DATE: January 30, 2026

ADDENDUM NO. 4

PROJECT NO. DGS C-0946-0012 PHASE 006
PROJECT TITLE - PA State Museum & PHMC Tower - Infrastructure Upgrades and Renovations
PROFESSIONAL:
Design Resources Group Architects AIA
270 Davidson Ave, Suite 303
Somerset, NJ, 08873

PHMC TOWER - BASEMENT MEZZANINE - ARCHITECTURAL RENOVATION PLAN 00BM

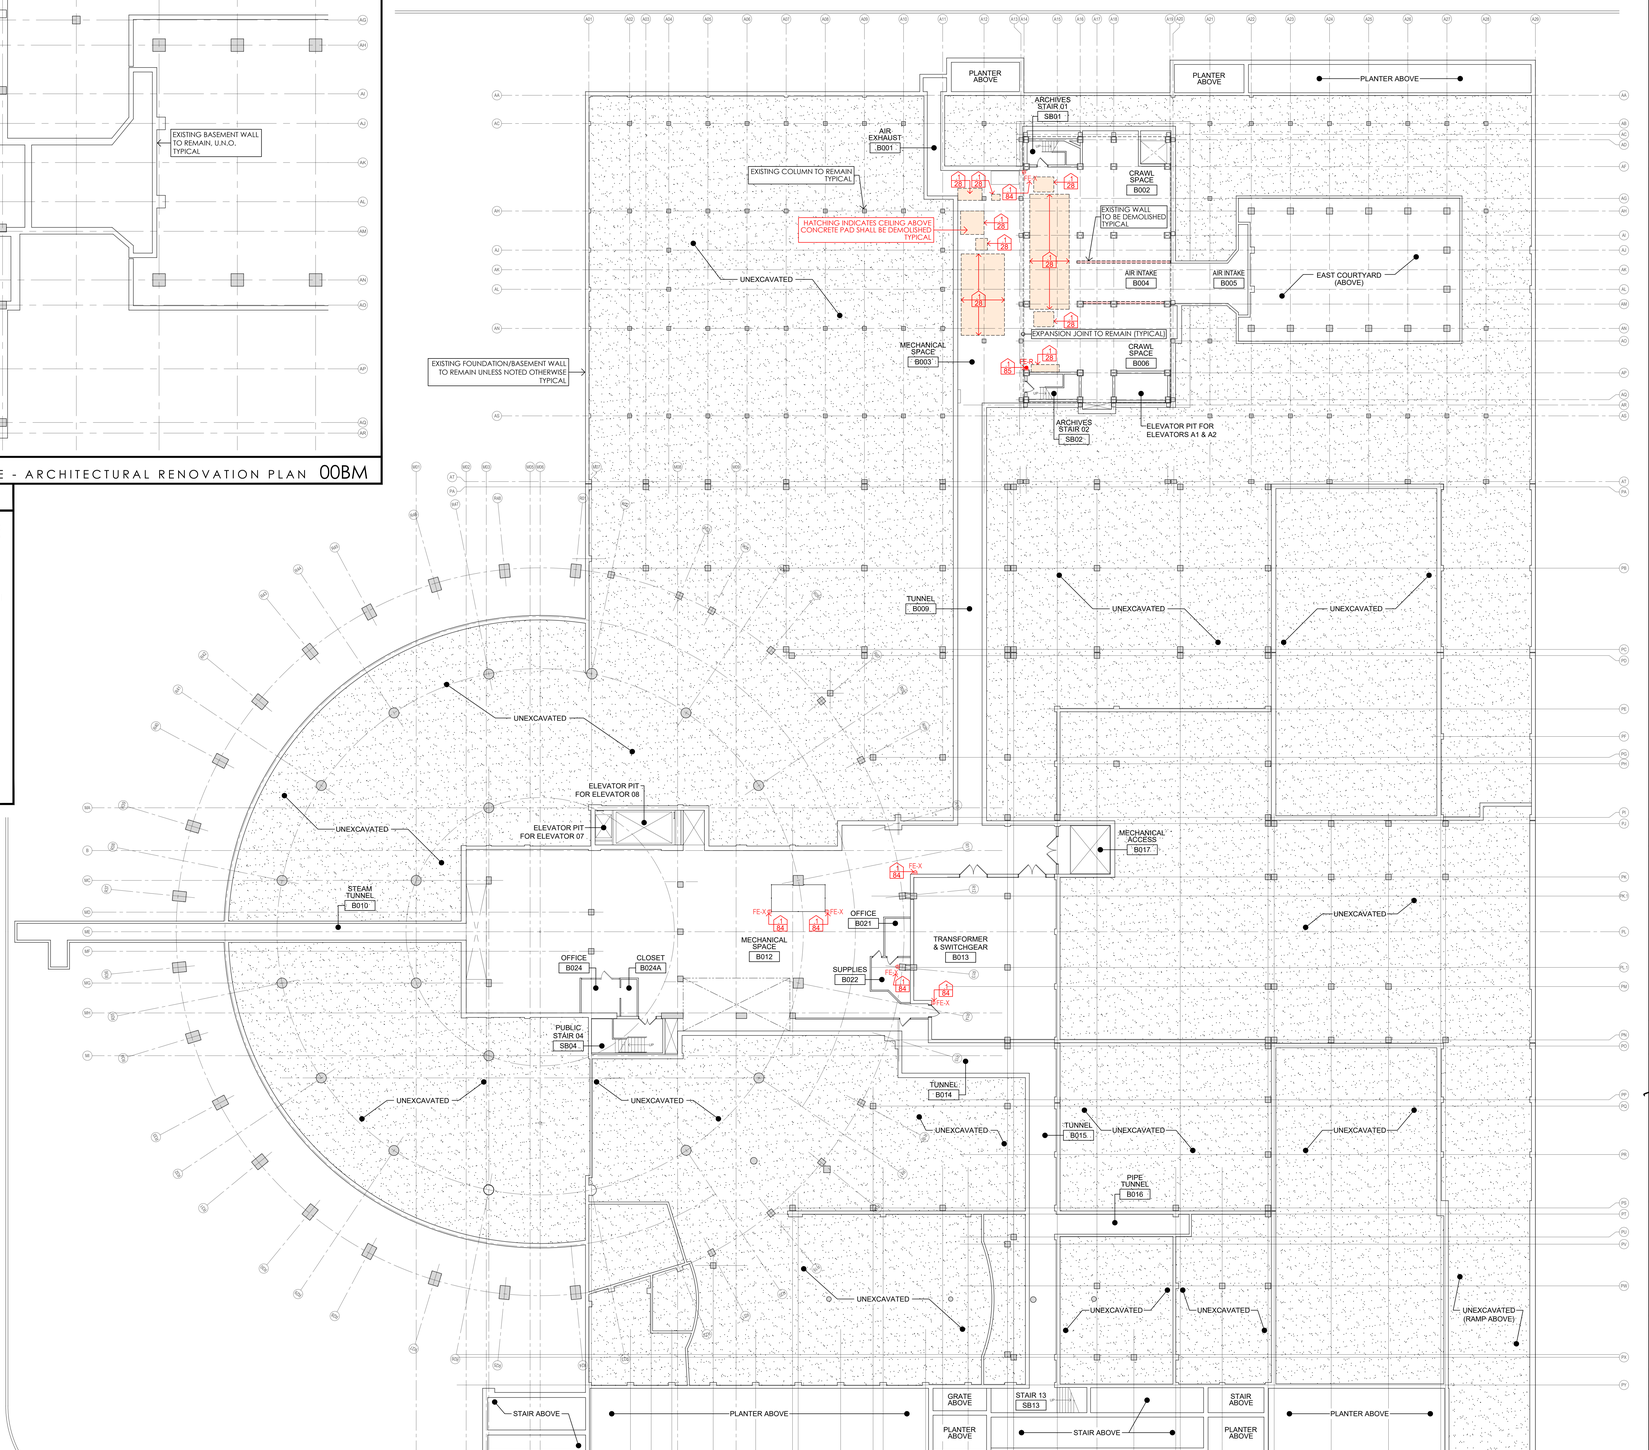
Item 6 - Drawing AD100B - At Plan 00BM, revised Demolition Note .1/23 to read .1/23 similar.

SCHEDULE OF TOILET ACCESSORIES 02

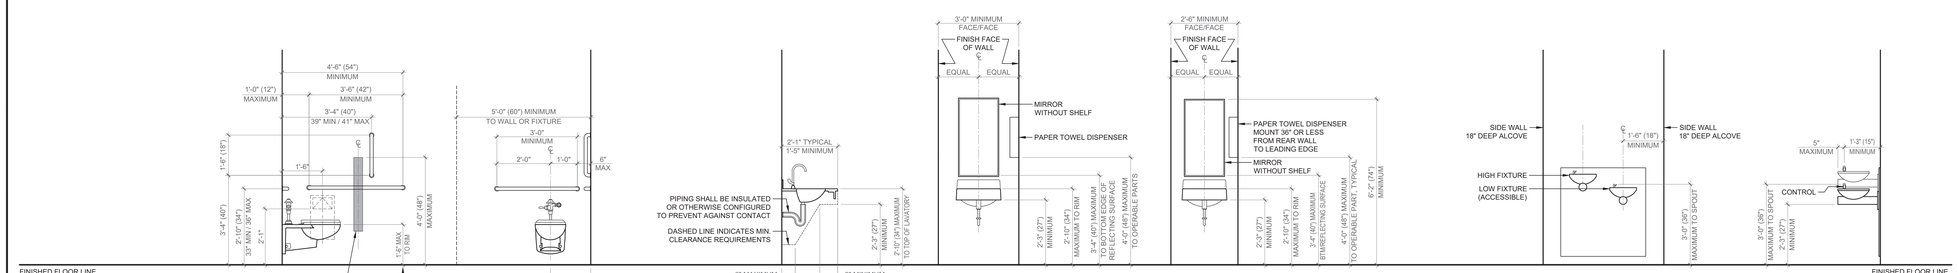
Item 21 - Drawing A130 - At Schedule of Toilet Accessories 02, revised the following:
Revised T10 to Not Used.
Revised T16 to recessed stainless steel baby changing station.
Added T17 adult changing table.

ENLARGED PLAN OF NURSING MOTHER GR093,RESTROOM R094/GR095/GR096/GR097/GR098 ADULT CHANGING GR099 01

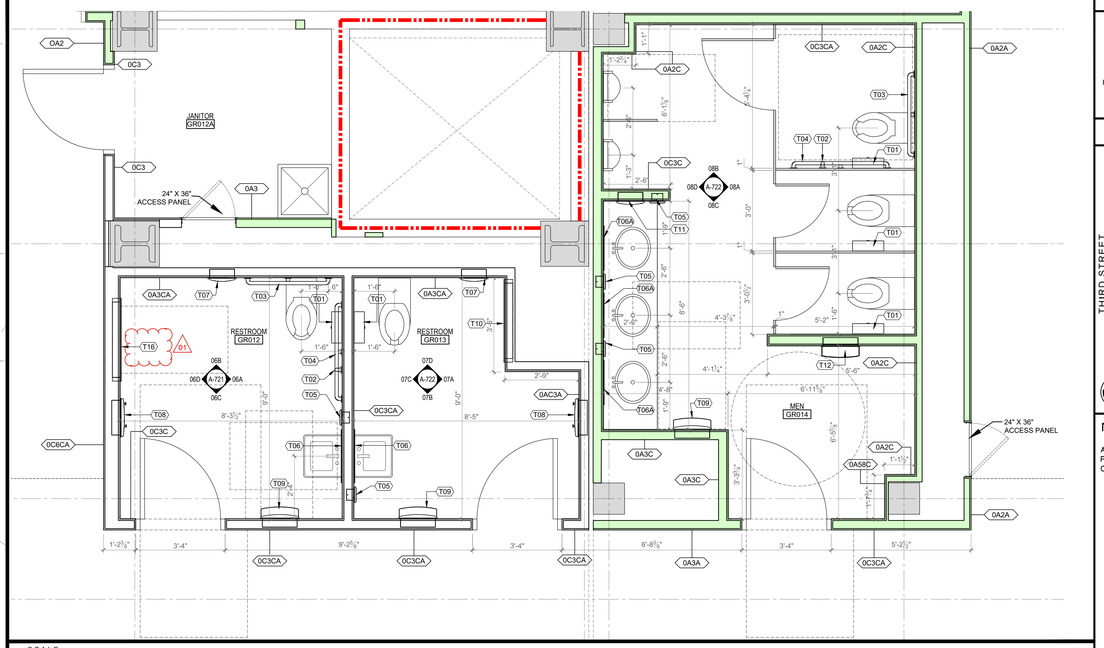
Item 23 - Drawing A131 - At the following rooms, revise toilet accessory tag T10 to T16 (baby changing station): Nursing Parents Room GR011, Restroom GR012, Nursing Mother's Room GR093, Restrooms GR094, GR095, GR096, GR097 and GR098, Men GR104, Women GR105.

Item 24 - Drawing A131 - At Adult Changing GR099, added toilet accessory tag T17 for adult changing table.

DRAWN BY: KEH	DATE: 10/10/2025	DRAWING NUMBER: MD100B
CHECKED BY: DC	SCALE: 1/16" = 1'-0"

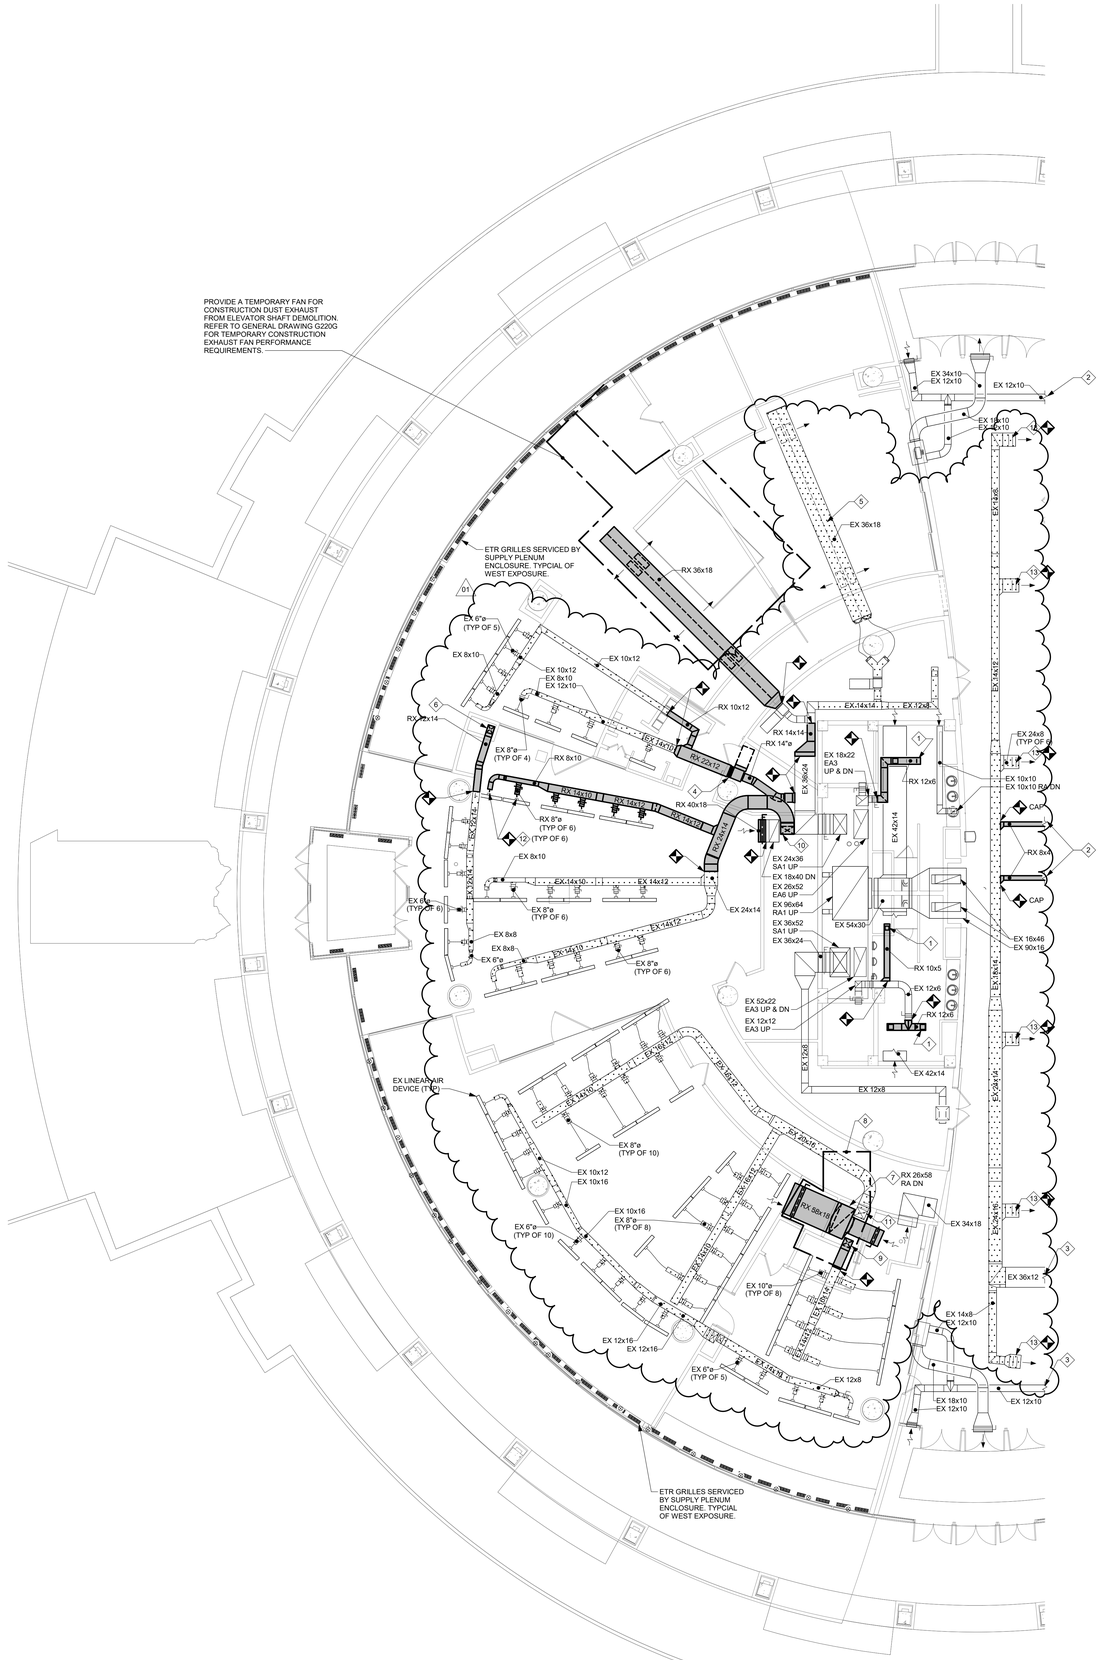
Item 72 - Drawing MD100B - Showed the extent of existing ductwork to be cleaned.

DRAWN BY	DATE	DRAWING NUMBER
KEH	10/10/2025	MD100G.1
CHECKED BY	SCALE	
DC	1/8" = 1'-0"

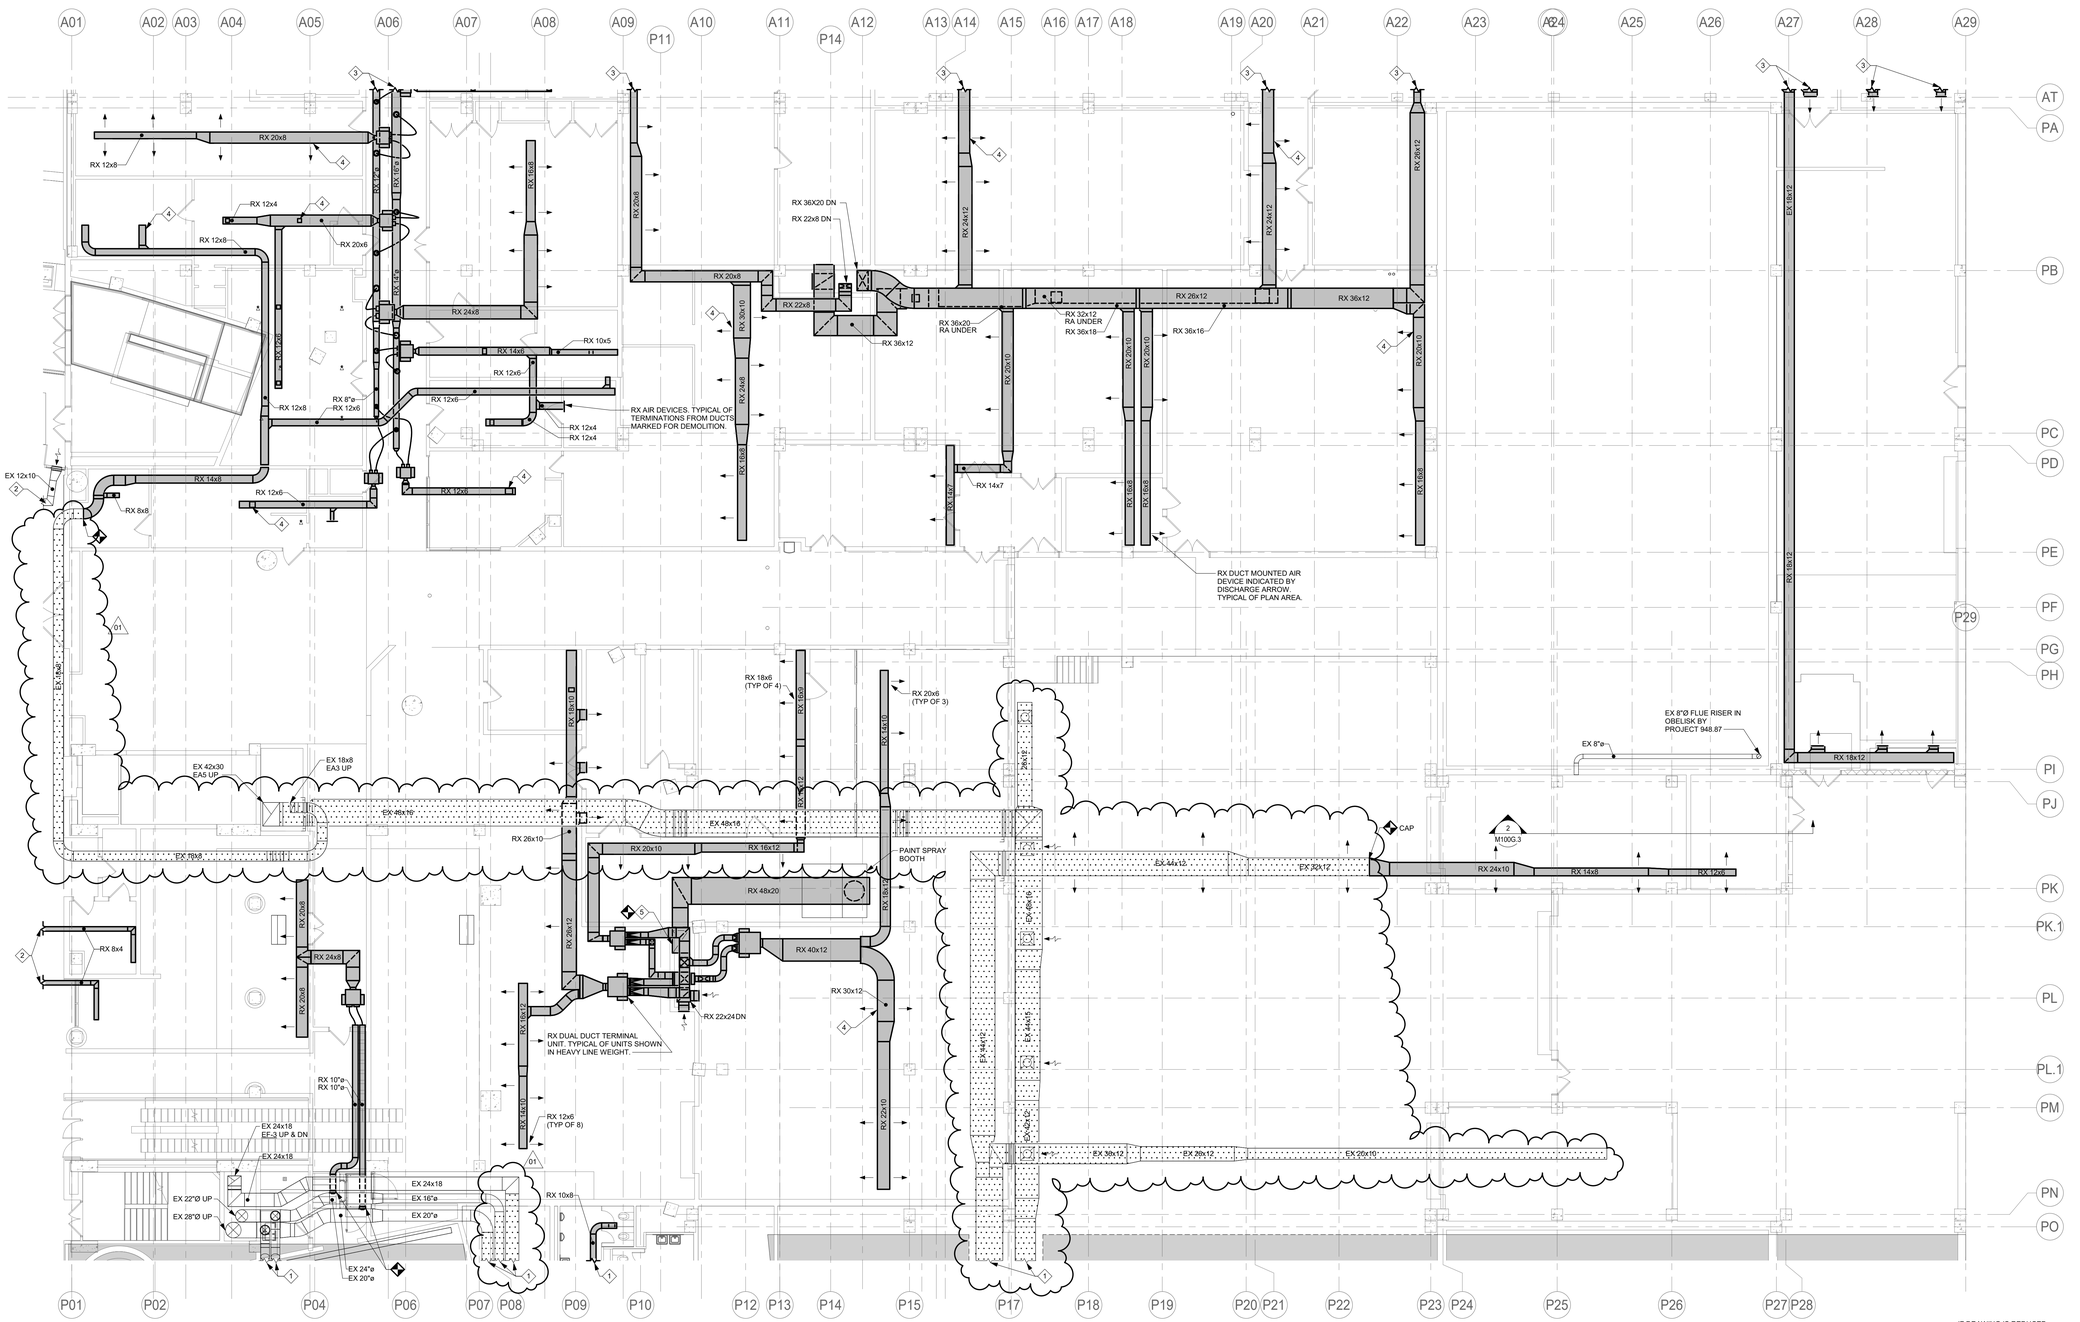
Item 73 - Drawing MD100G.1 - Showed the extent of existing ductwork to be cleaned.

1 MECHANICAL DEMOLITION PLAN - GROUND FLOOR - PART 4
MD100G.4 1/8" = 1'-0"

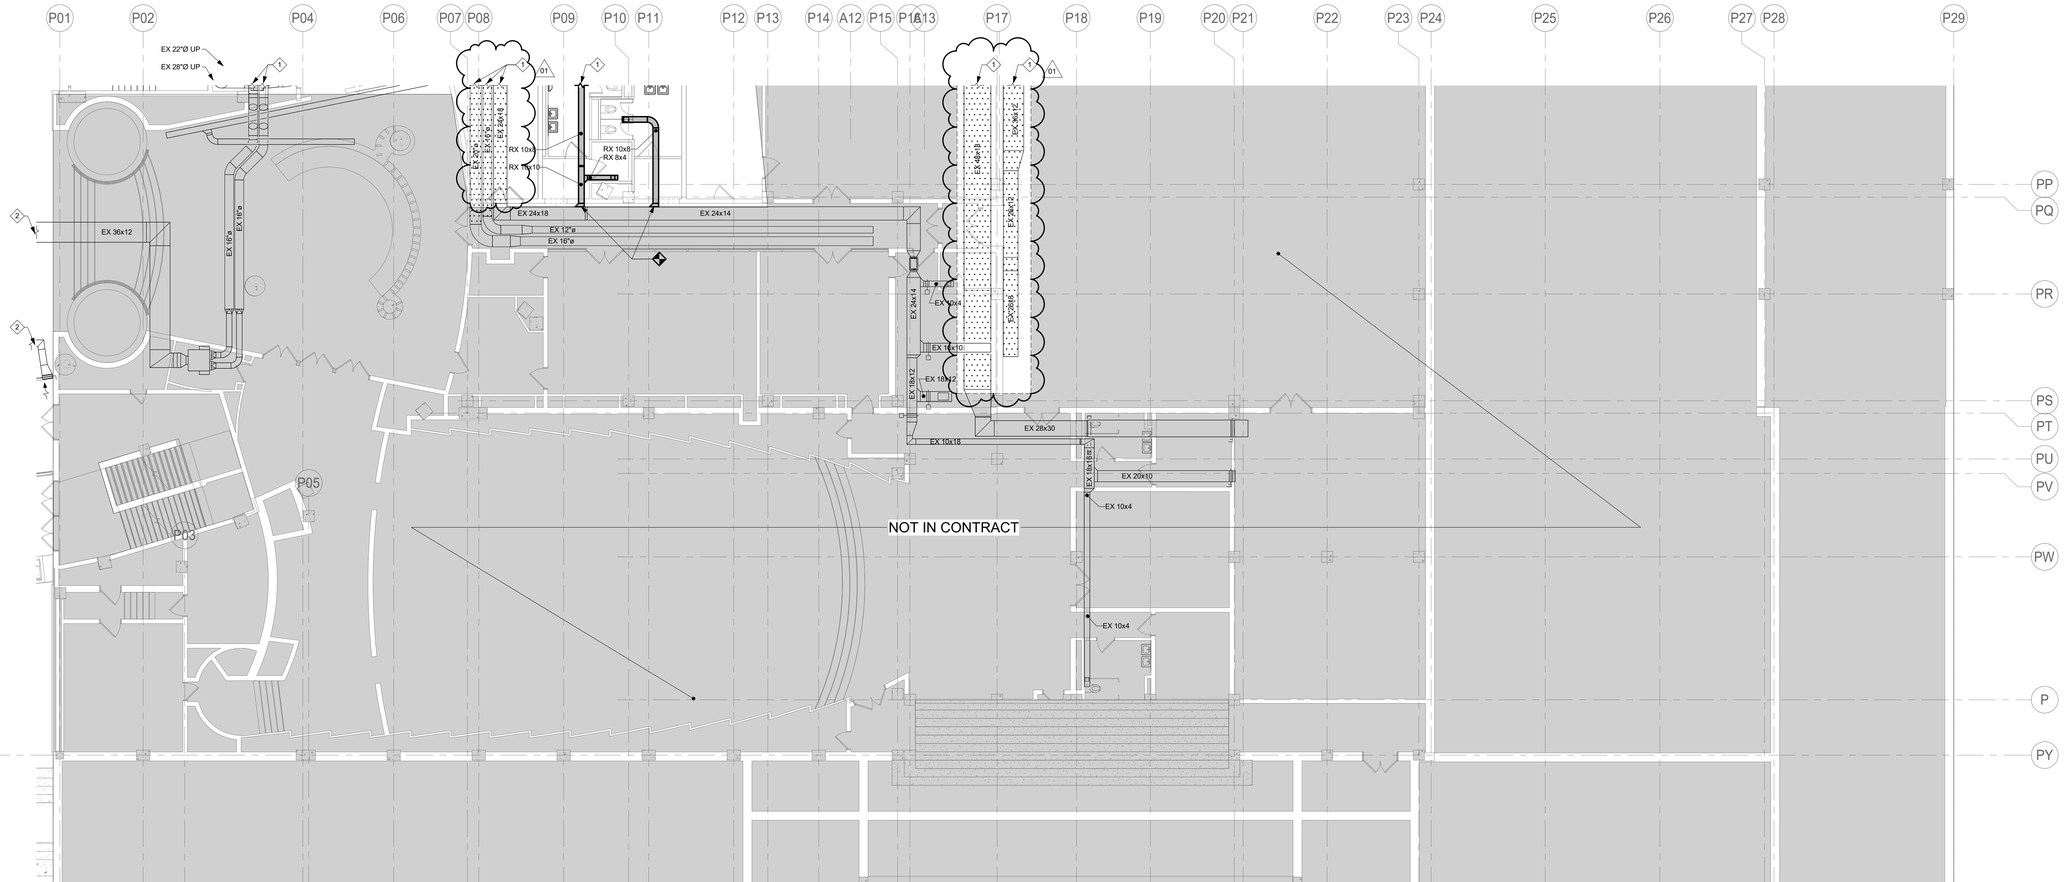
Item 75 - Drawing MD100G.4 - Showed the extent of existing ductwork to be cleaned.
